**City of Portland
Portland International Jetport
Phase I Parking Garage
City of Portland Major Site Plan Application
Response to Comments**

March 9 2001

**RE: Portland International Jetport - Phase I Parking Garage Improvements
Planning Board Submittal - Response to Comments**

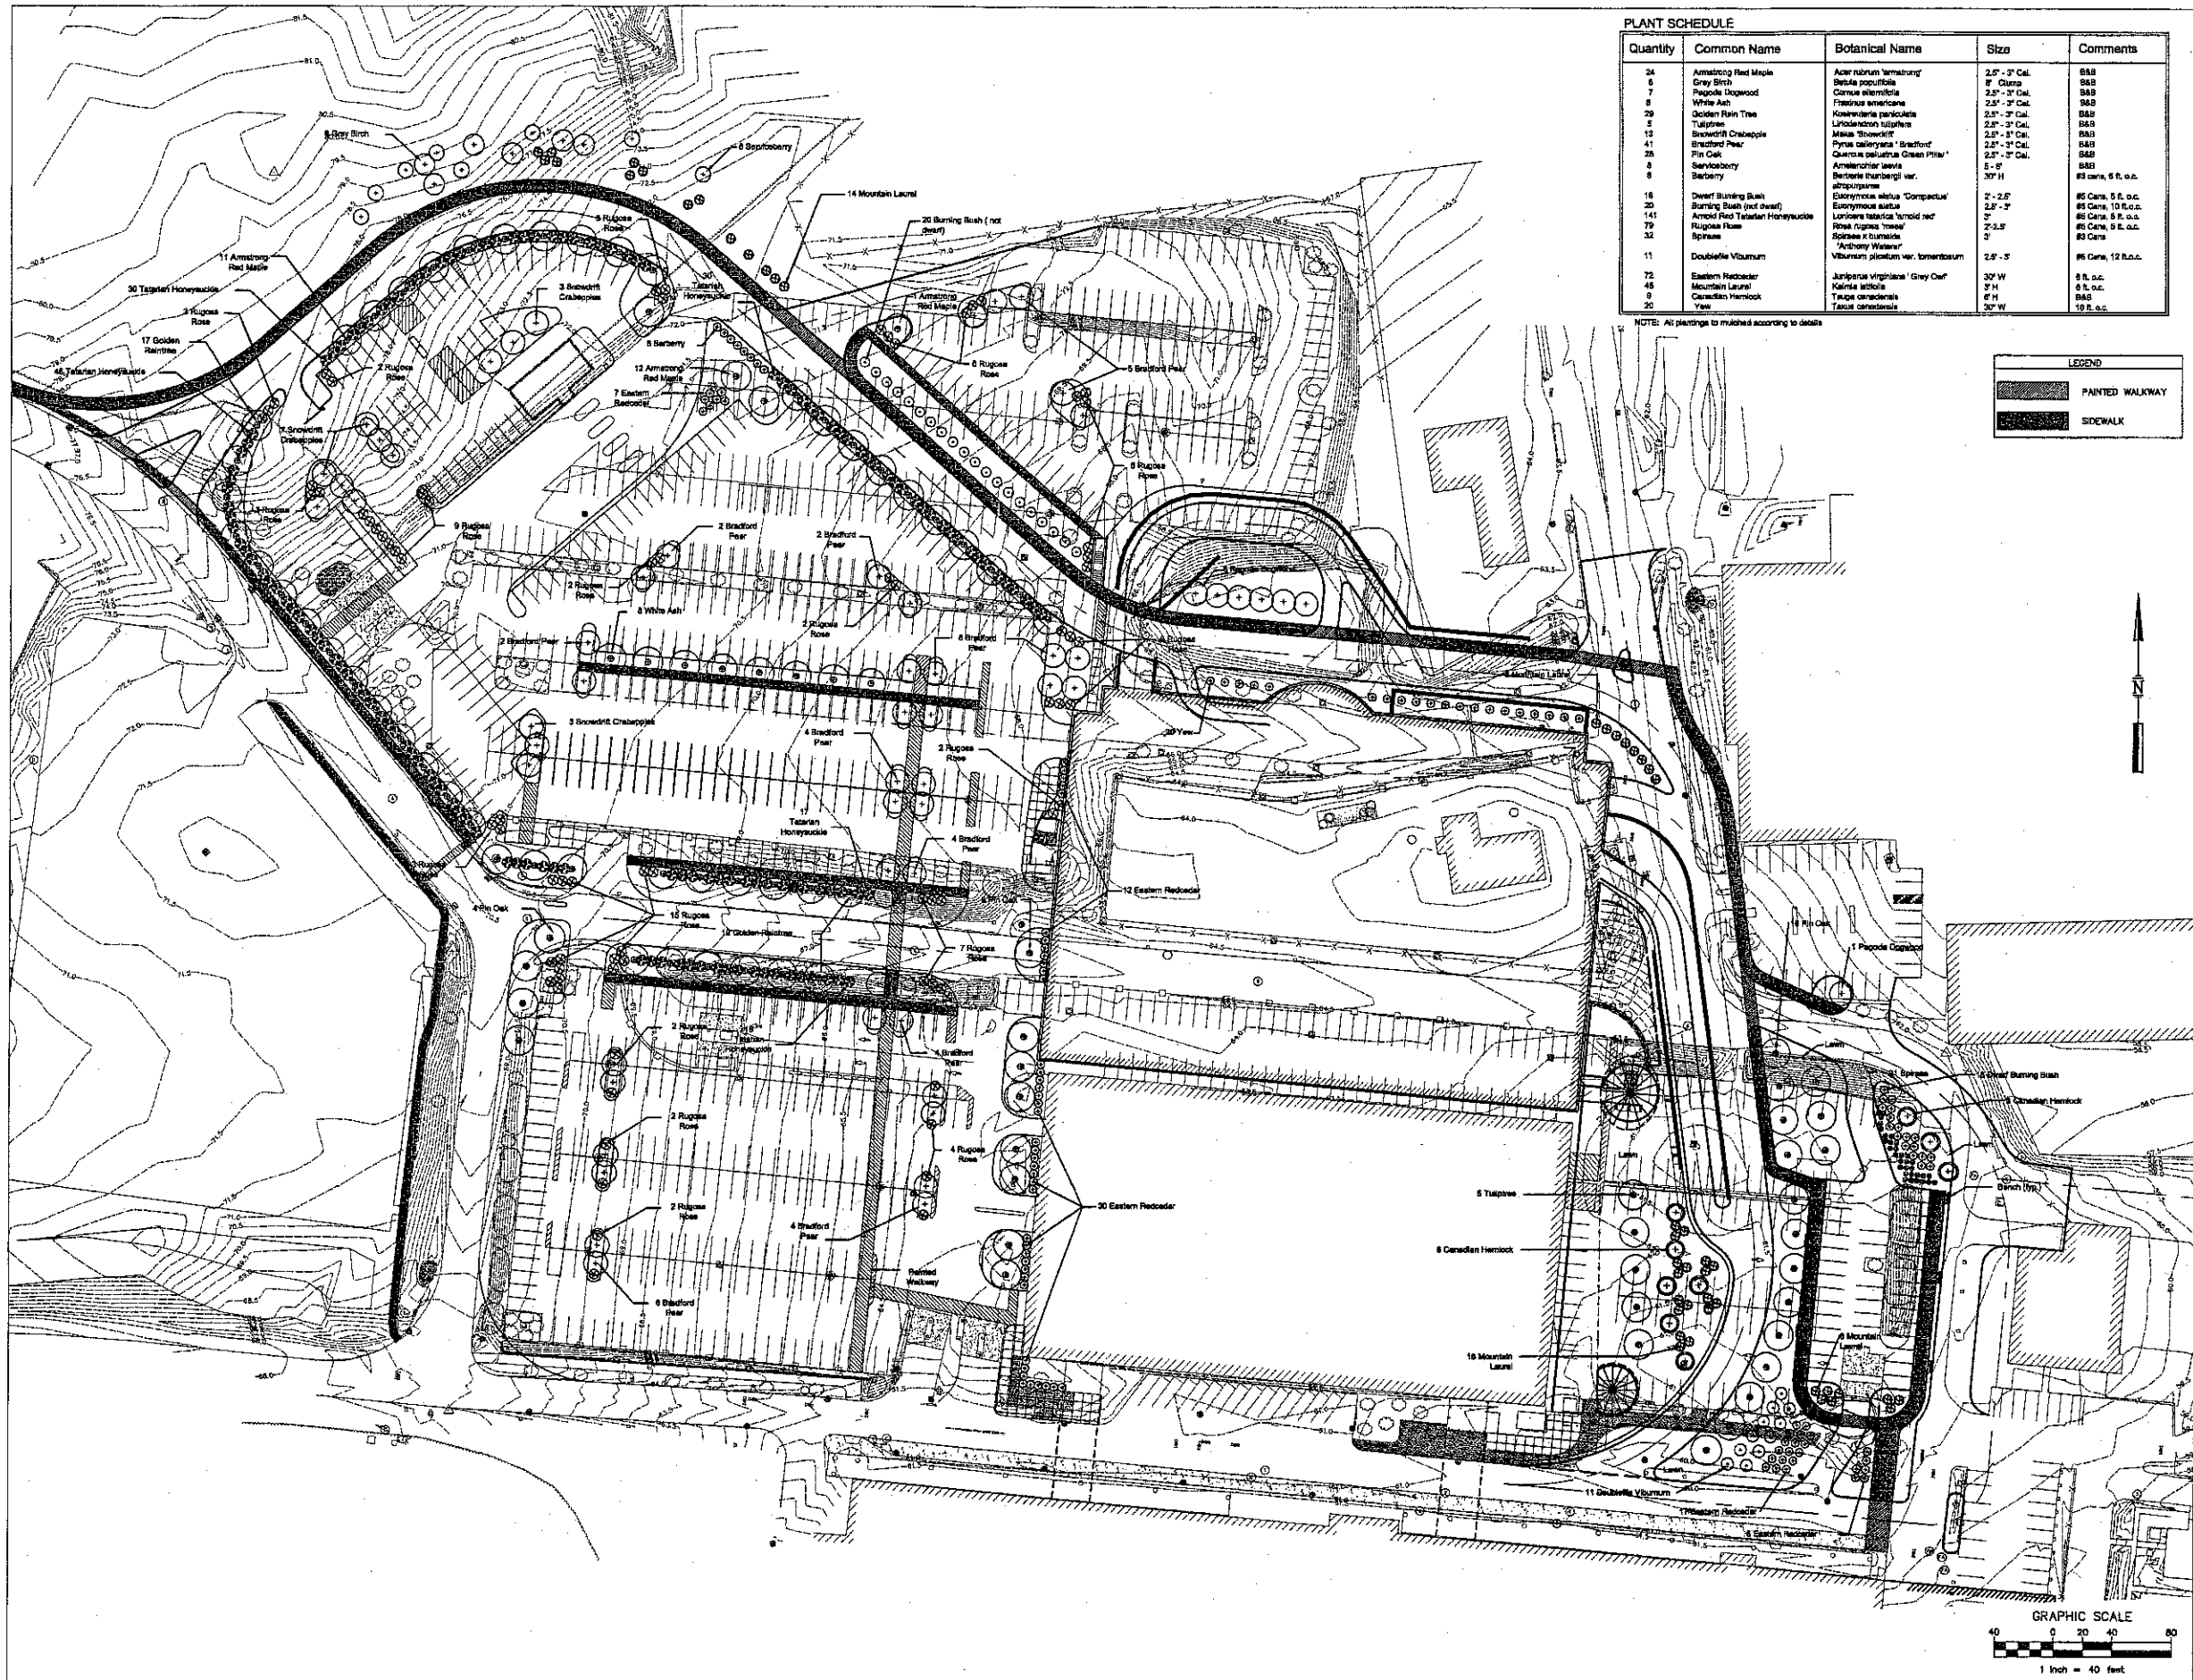
- ▶ **Sidewalk and crosswalk comments. See attached sketch. Also the interior walkway from the easterly side of the parking garage should be shown.**

- ▶ **On the pedestrian movement plan, there is a sidewalk along the face of the existing terminal building. Heading westerly, the dots go past the existing sidewalk to the loop road intersection. Is the sidewalk going to be extended to the loop road intersection? Also, shouldn't the cross walk be at a right angle to the street rather than the curving cross walk shown on the plan?**

A crosswalk has been added to the Landscaping Plan Sheet LI-1 as shown on the provided sketch. The attached Pedestrian Movement Plan Sheet A-PF1 shows the interior walkway from the easterly side of the parking garage.

The crosswalk has been revised to be perpendicular to the terminal access road and is shown on the Landscaping Plan Sheet L1-1, the Pedestrian Movement Plan Sheet A-PF1, and the General Layout Plan Sheet C1-3. The Jetport is planning a new sidewalk on the south side of the terminal access road not part of this contract. Therefore, pedestrian movement is across the terminal access road onto a sidewalk that leads to the face of the terminal building. This eliminates the need for pedestrians to cross traffic to the terminal building since there is no traffic coming from the west entrance to the terminal access road.

A-PF

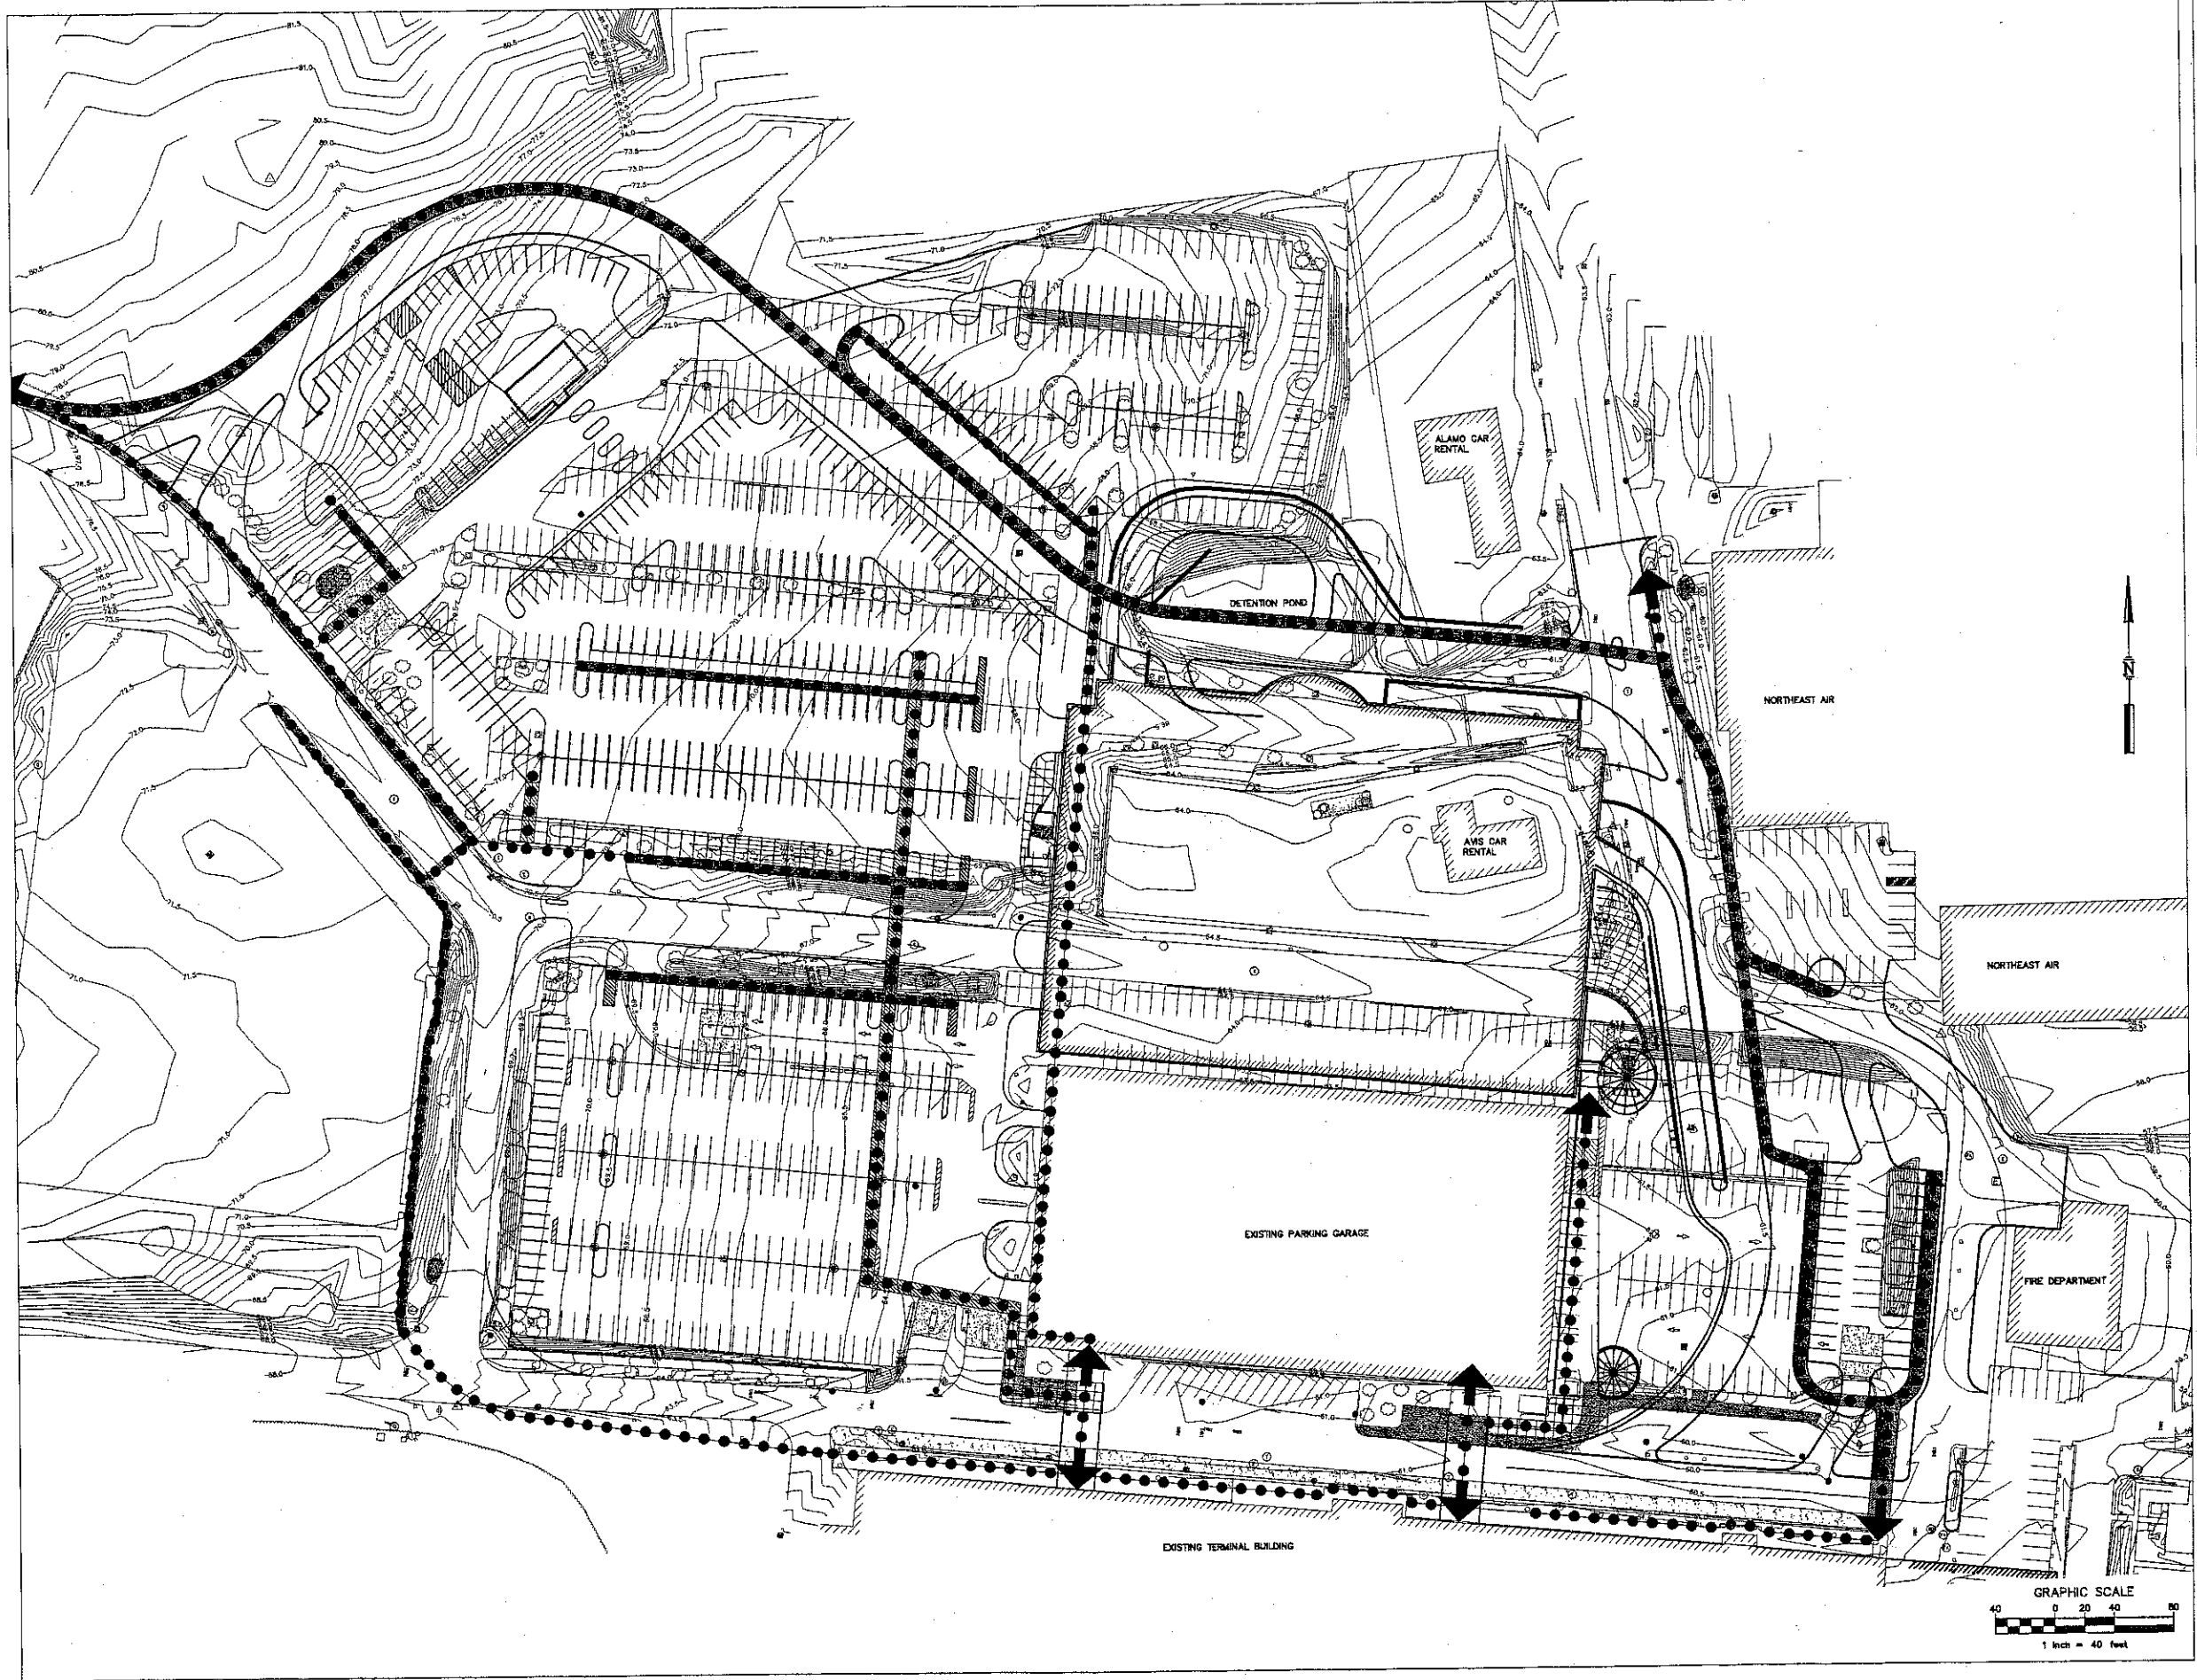
- ▶ **The pedestrian movement plan shows circulation along the westerly side of the new parking garage through the existing parking garage. This doesn't seem to be consistent with sheet A-PF. Is the circulation along this area intended to be inside, outside the building or both?**

Circulation is intended to be inside the building. Sheet A-PF has been revised to include the pedestrian movement to the existing garage on the westerly side.
